Land to the East of Longwater Road, Finchampstead

Addendum Arboricultural Note

edp4070_r015a

Plan EDP 1: Tree Protection Plan
(edp4070_d034c 18 November 2024 DJo/GSn)

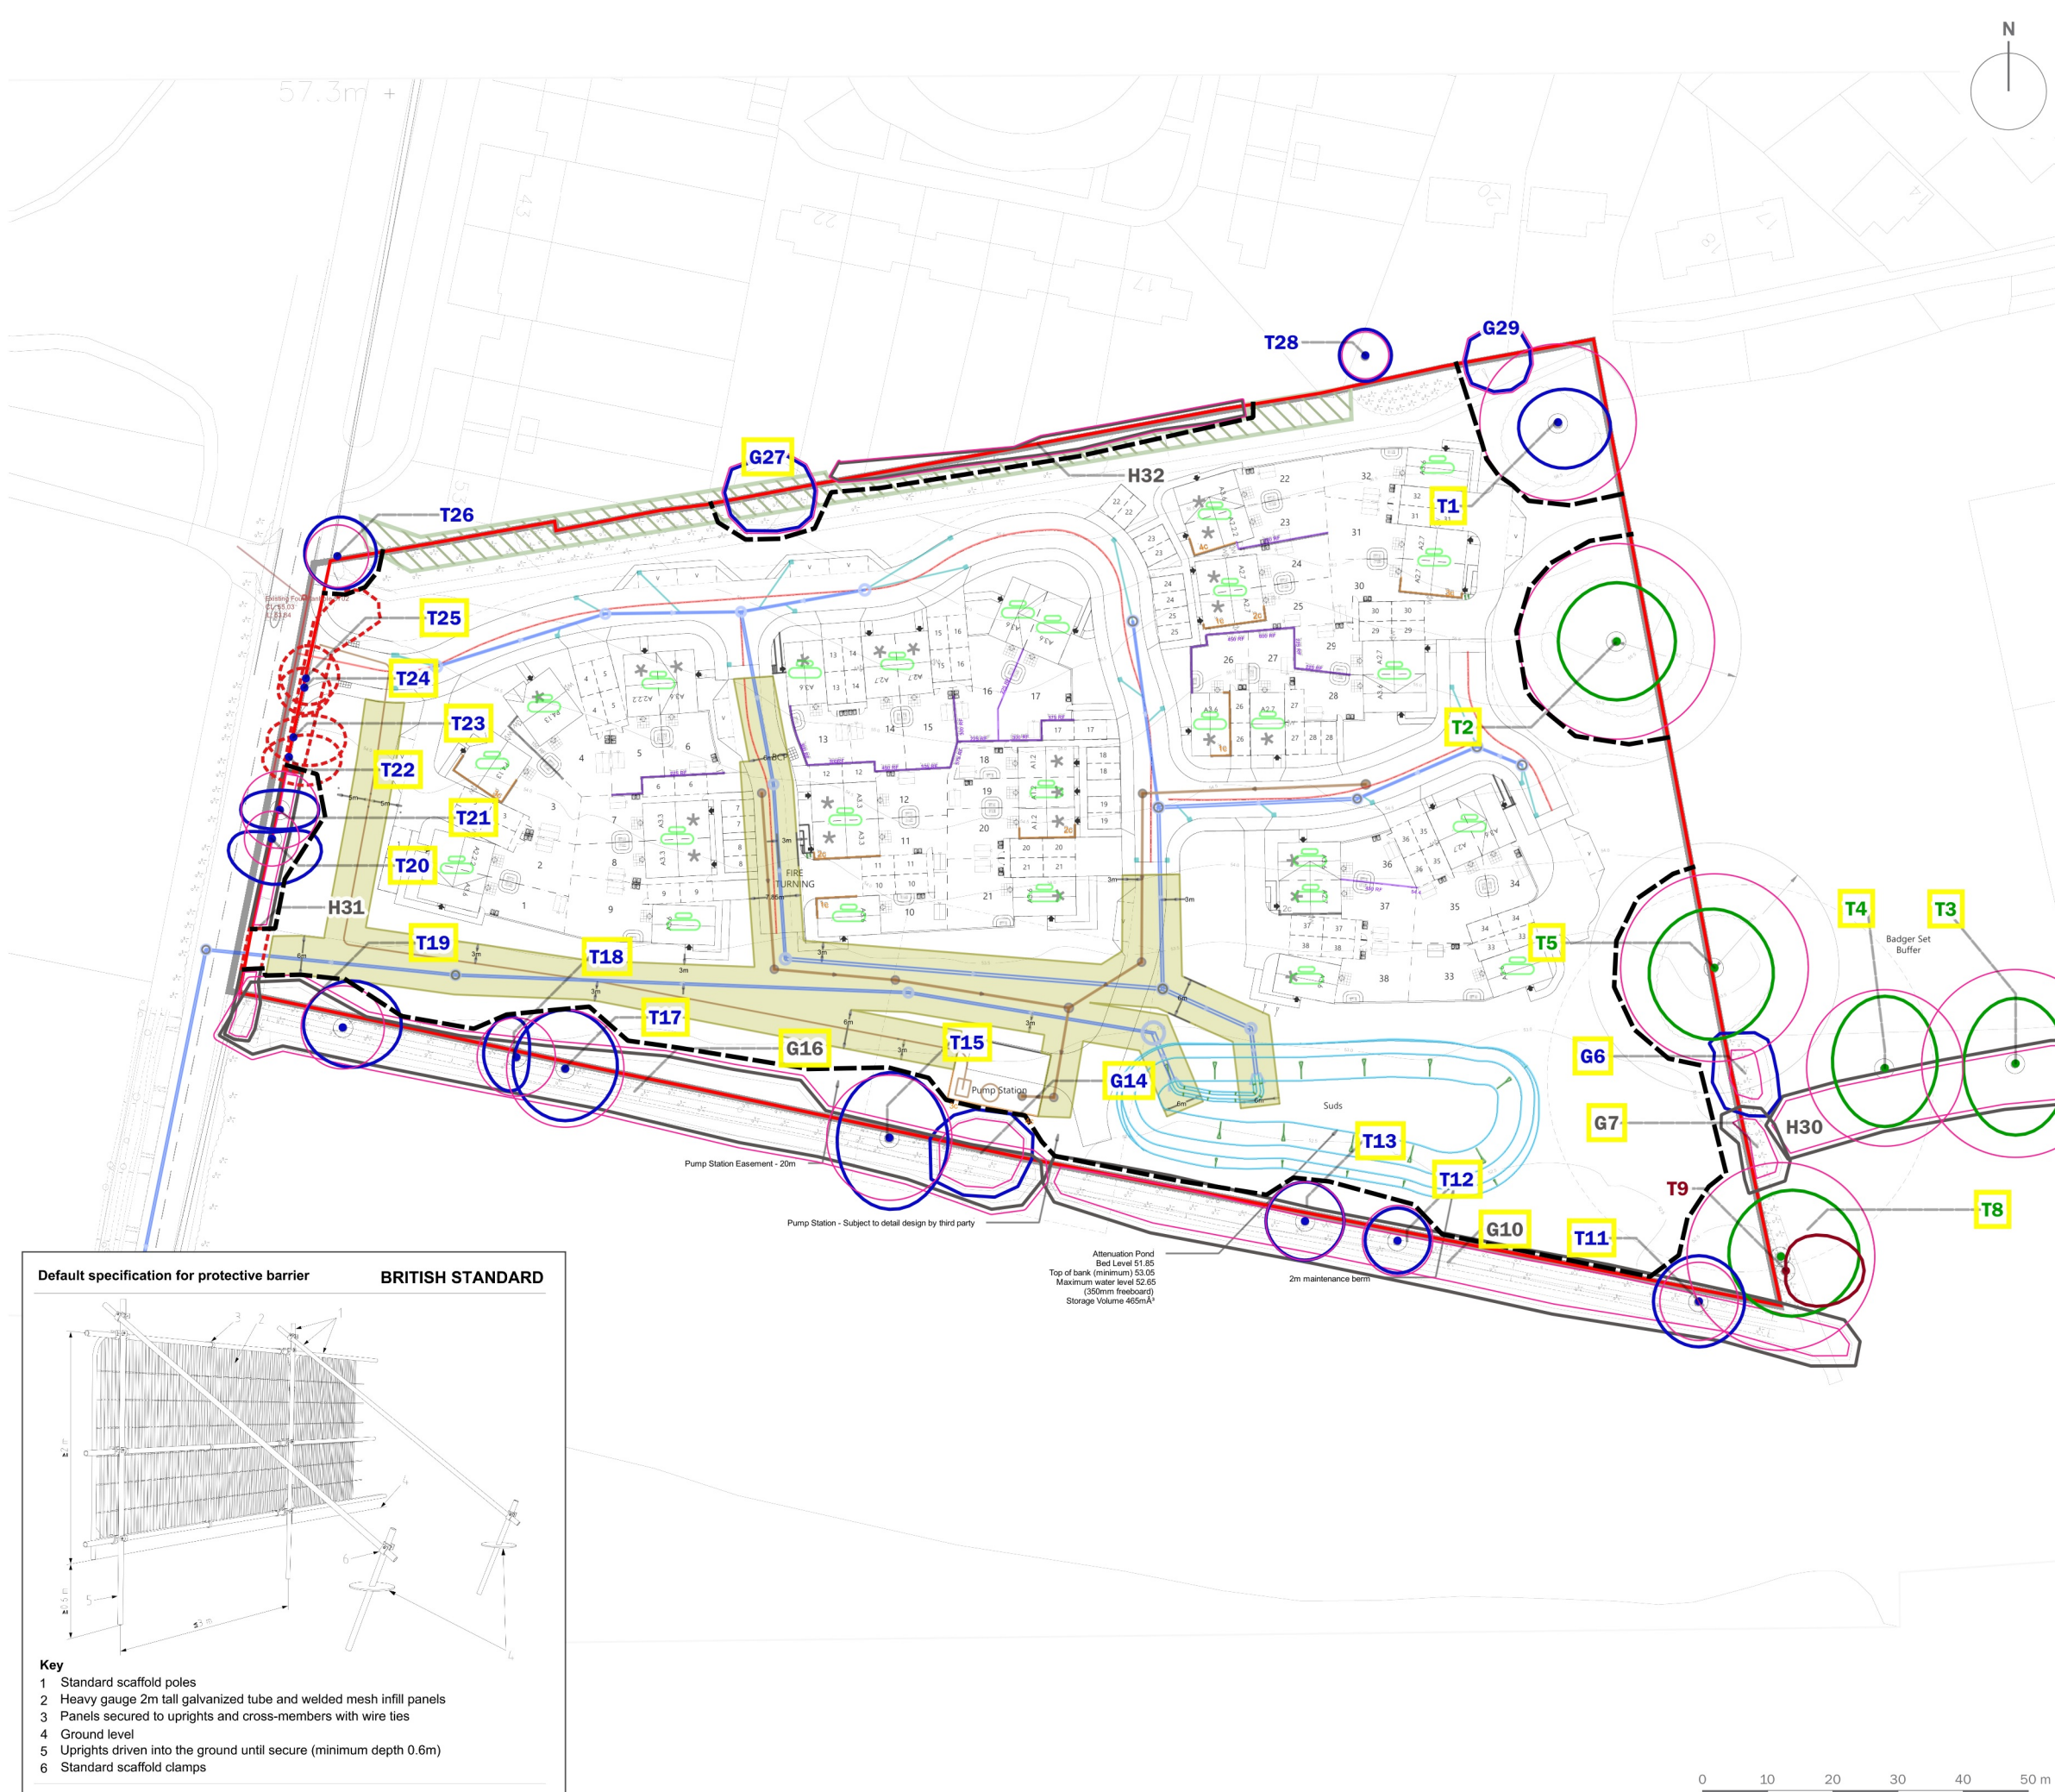
- 2.1 In their response to the original submission, the Landscape and Tree Officer highlighted the amenity, ecological and arboricultural value of **T2** and suggested it is a veteran tree. However, a Recognition of Ancient, Veteran and Notable Trees (RAVEN 2) assessment was undertaken during the original survey, and it did not qualify as a veteran, however, **T2** does have notable features. To allow **T2** to continue to age and veteranize, an extended area free from construction has been allowed for within the proposal. The suggested radius of 19.2m of no construction by the Tree Officer will allow this notable tree greater protection.

- 2.2 To facilitate this additional area, the units and surrounding hardstanding have been repositioned so that there is now no development within the 15m root protection area (RPA) or the extended area beyond the RPA totalling 19.2m of this high quality Category A oak.

- 3.1 In response to the comments made, the proposed units and hardstanding have been repositioned away from **T2** to facilitate a recommended construction free area, and

although not previously impacted by the original proposal, **T5** has also been afforded the extended area as well ensuring both trees can flourish within the setting. The updated layout (**Appendix EDP 1**) will result in fewer impacts to the trees on the Site. However, the updated layout will still result in the loss of four category B trees of moderate quality to allow access to the Site and the required visibility splay, and the partial removal of **H31**, a category C hedgerow of low quality, that being the northernmost section, to facilitate the main site access.
